MANHATTAN VILLAGE ENHANCEMENT

Manhattan Beach City Council
April 29, 2014

Addressing City Council's Request

REVISED NORTH DECK SECTION (Reduced by 45 stalls)

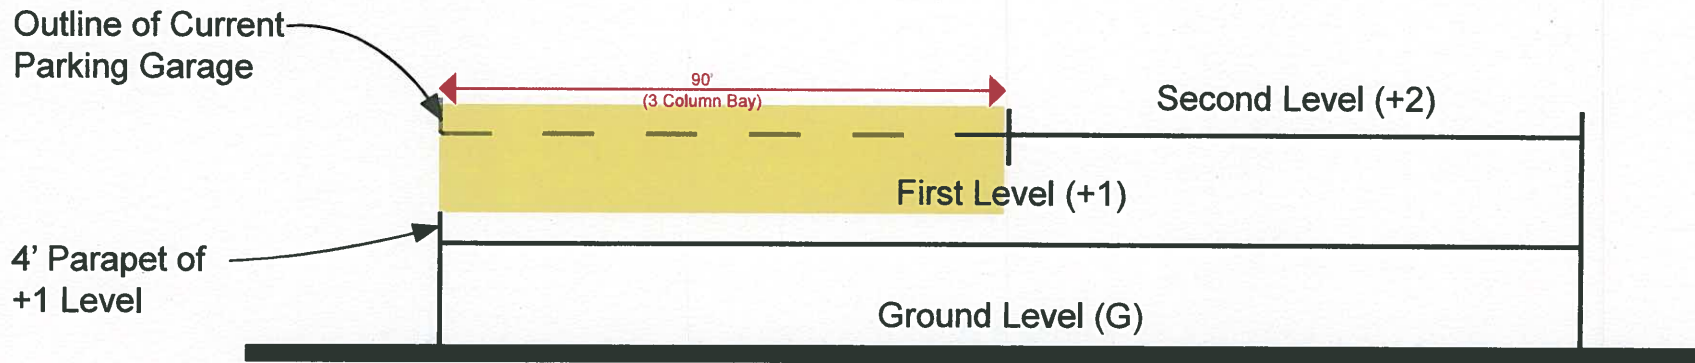
“Redesign the Phase I North parking structure similar to the Phase I South parking structure.”

- RREEF has reduced the North Deck by contracting the top level by approximately one half on its west side, so that approximately half of the deck is G+1
- North Deck now has the same G+1.5 configuration as the South Deck
- Hanging vines will be incorporated in the north and west upper levels of the deck
- Mature landscaping will screen perimeter of the deck

Request 5

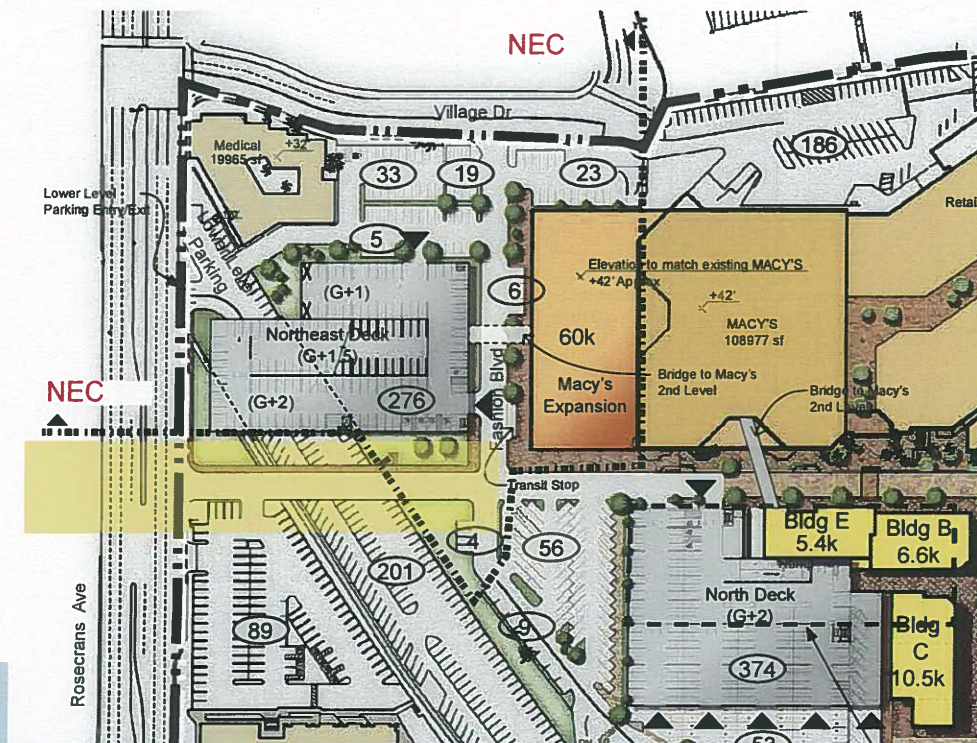
“Cedar Way must connect to Rosecrans with Phase II.”

- ✓ Cedar Way will be connected to Rosecrans as part of Phase II construction
